**AGENDA
PLANNING COMMISSION**

Thursday, May 07, 2020

1. [Hillside Development Permit 14-02 \(HDP 14-02\) and Conditional Use Permit 14-08 \(CUP 14-08\); to allow construction of a new single family residence with an attached two-car garage for a total of 4,502 square feet at 9 Nathaniel Terrace, Lot 5 of Tract 54016, in the Stonegate development area](#)

2. [Modification to Administrative Hillside Development Permit 17-02: A request to modify the previously approved plans and elevations of the primary residence at 751 Oak Crest Drive](#)

FLOOR PLANS COMPARISON

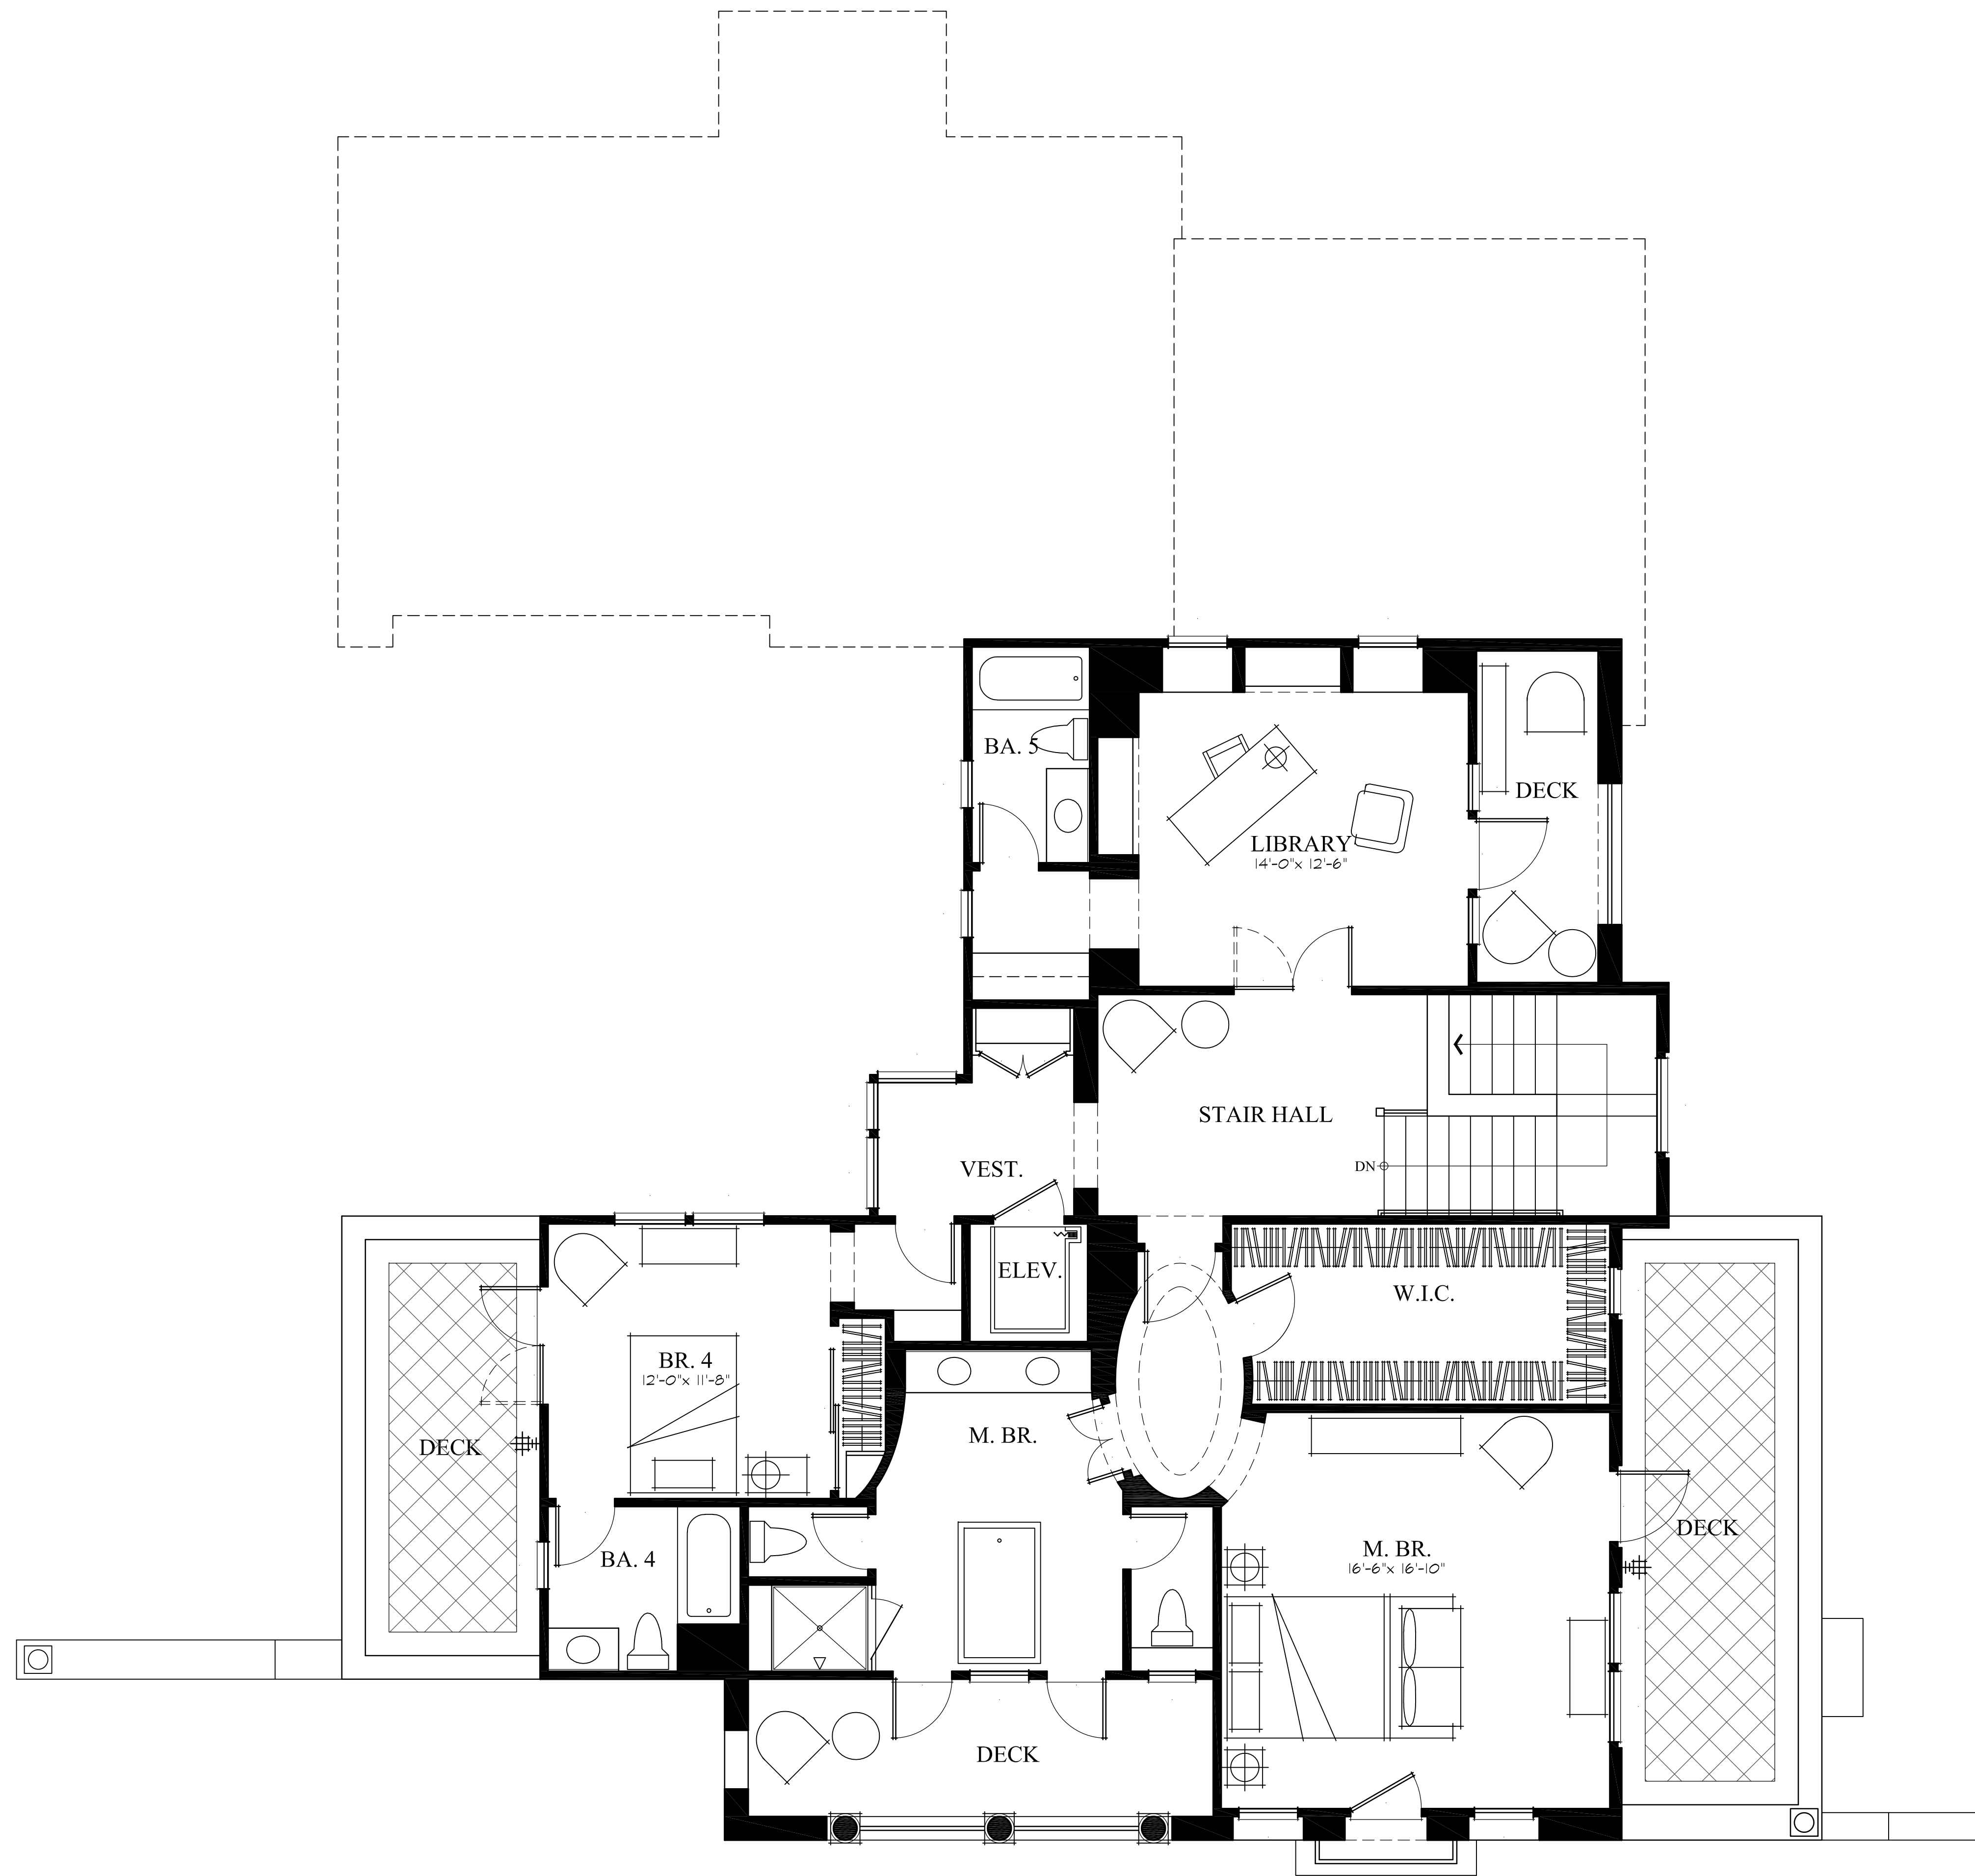
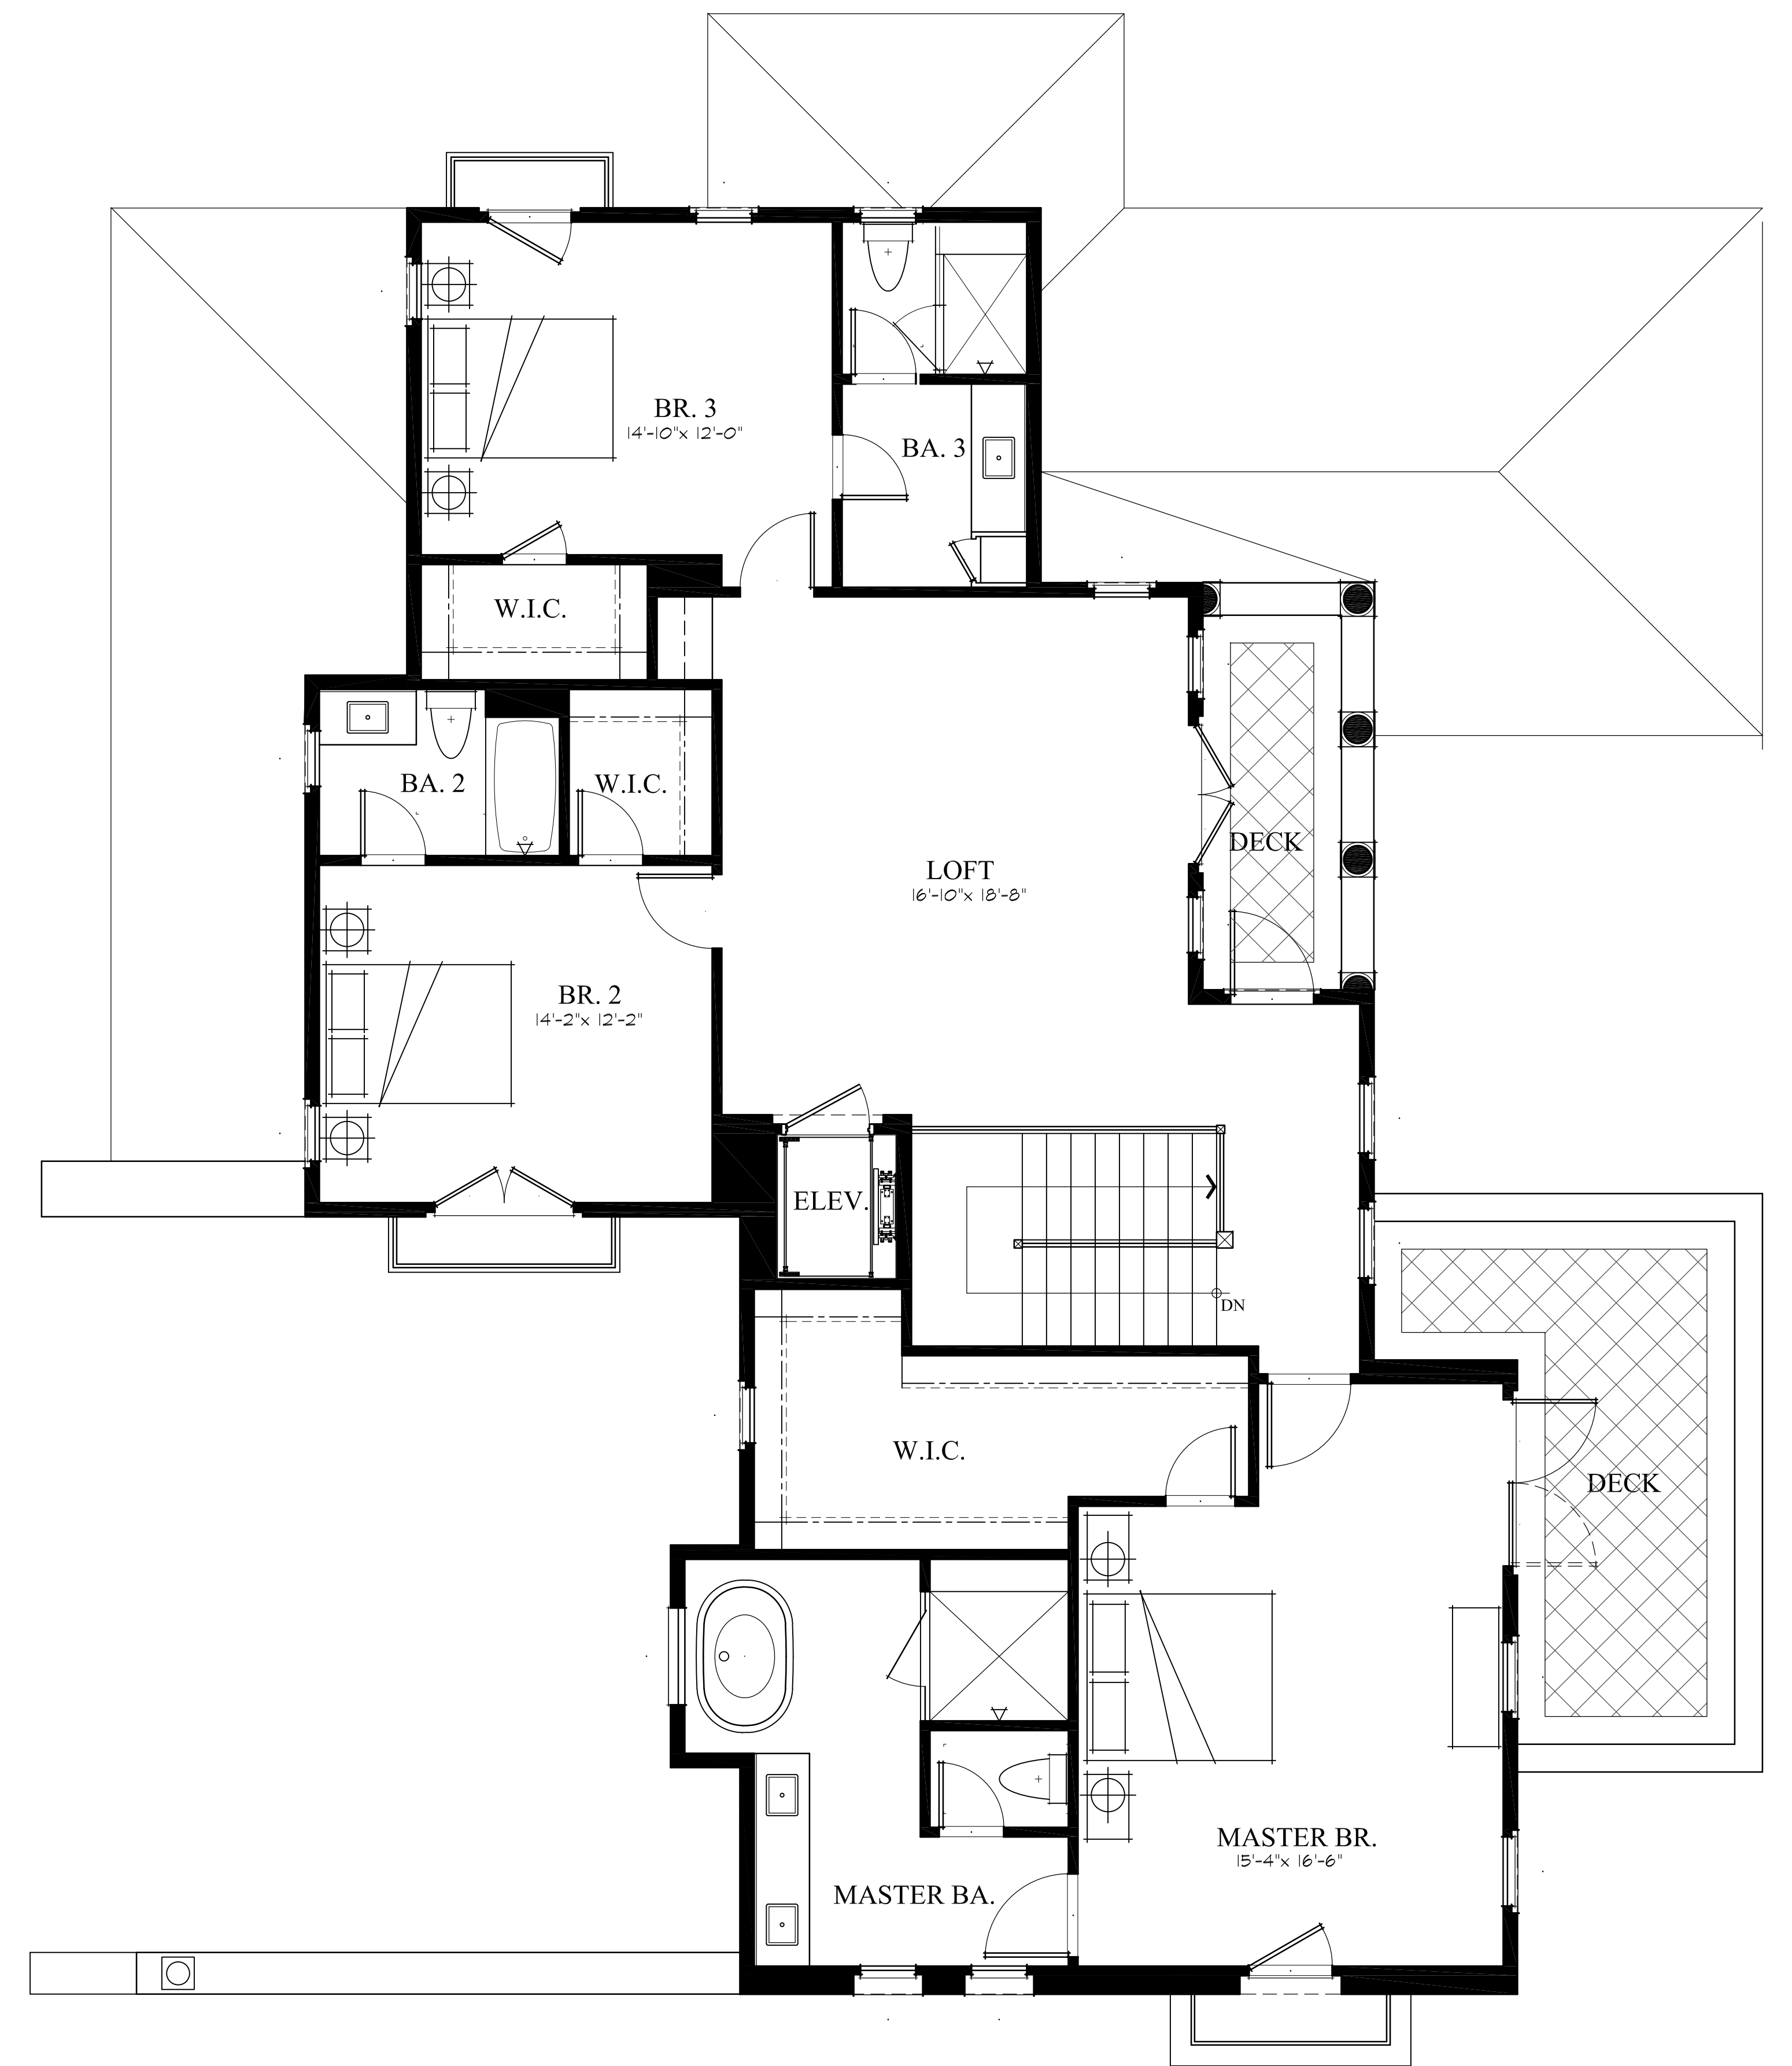
Commission Comment #2: Consider moving the mass to the north, reduce the stucco massing on the west facing building elevation, and study the prominent southwest corner with lower arms to the south.

Architect's Response: Second floor massing is relocated to the northeast corner. Library and the deck above set back 8 feet from the front wall. South facing building elevation is condensed by eliminating the lower wing wall and bedroom on the second floor. Bulk and mass are significantly reduced at the southwest corner.
